# City of Portland, Maine - Building or Use Permit Application

Proposed Project Description: <b>Remodel existing 3 unit apartment, chsnge rear deck, install hot tub with deck</b>		Pedestrian Activities District (P.A.D.)	
Signature:		Signature:

Re: 120 Baxter Boulevard – 111 B006 – R-5 – Permit #2011-07-1709  
17 Codman Street – 129 G011 – R-3 – Permit #2011-07-1712  
209 Stevens Avenue - 177 I010 – R-5 – Permit #2011-07-1708

**AN APARTMENT RENOVATION FOR:**  
**CODMAN ST. APARTMENTS**  
17 CODMAN STREET  
PORTLAND, ME 04103

Issued: JULY 15, 2011  
Scale: AS NOTED 0 1/2" 1"  
Drawn By: MA & SPR  
Reviewed By:  
BASEMENT & FIRST FLOOR PLANS  
**A-1.0**

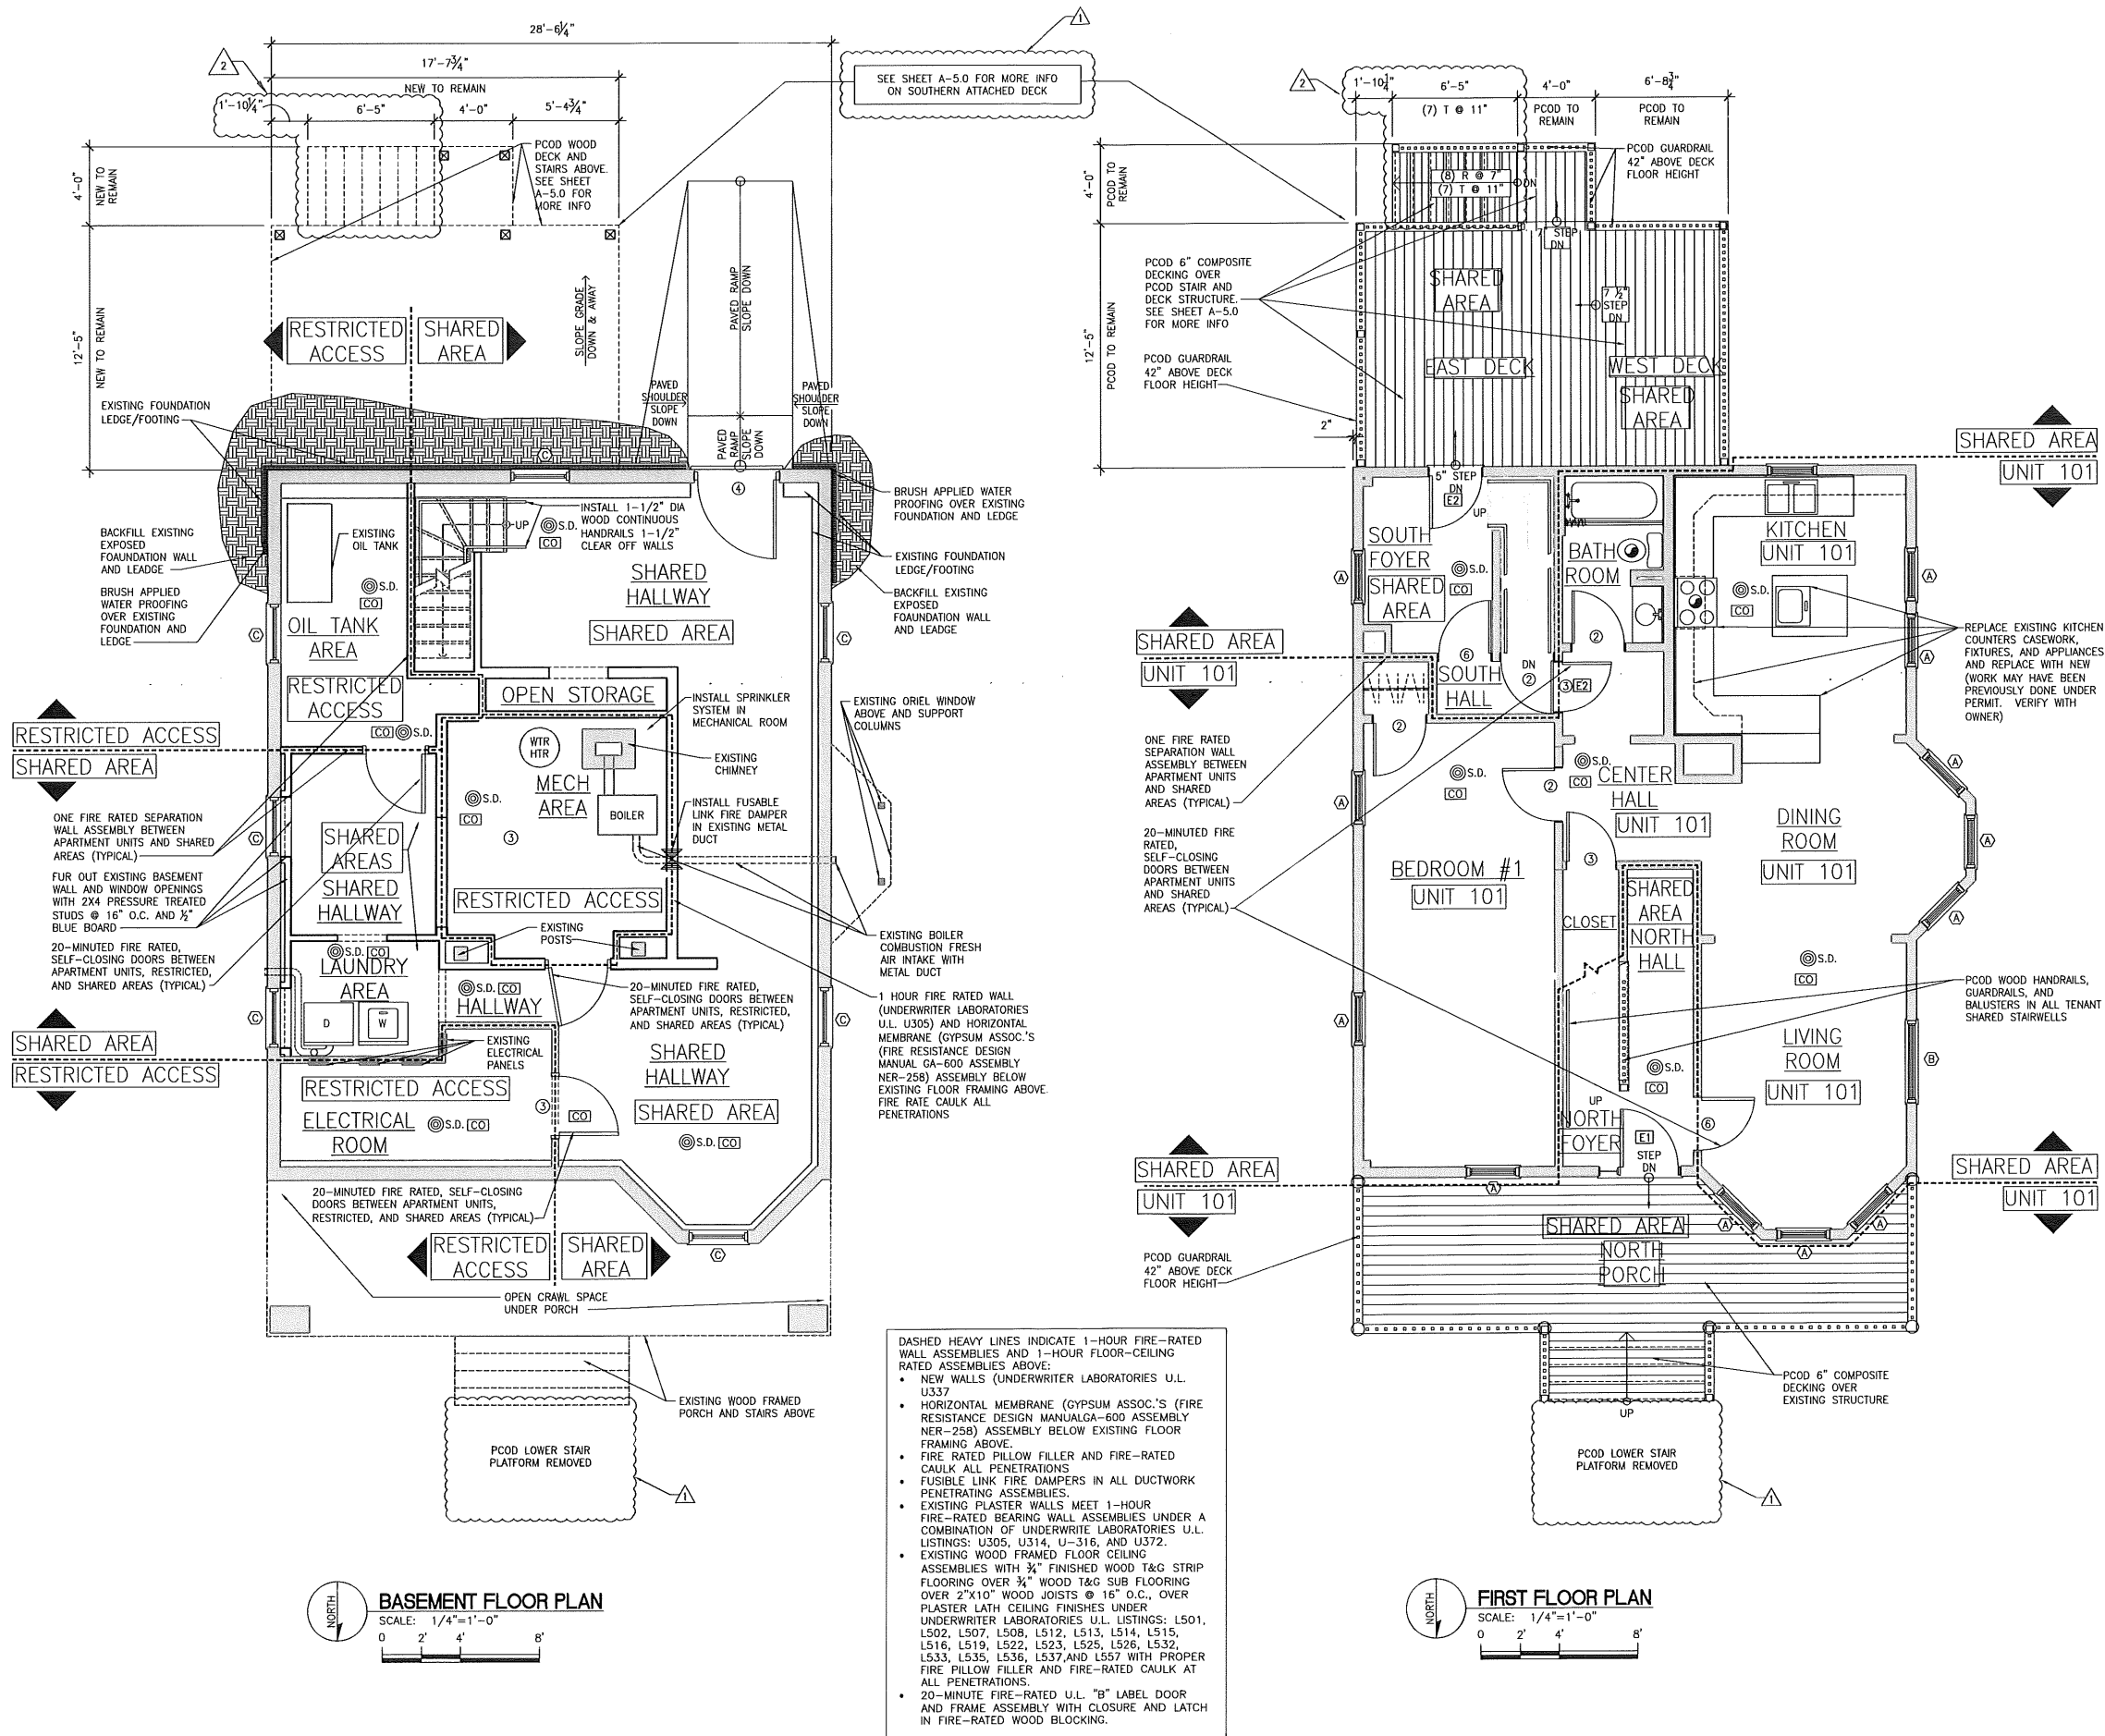
A-1.0  
Treads @ 10 3/4" - A.S  
Need 11" → Shows 11" + 7/8" w/prosiding  
Halls - common areas  
1 hour?  
Hot tub stairs - 11"
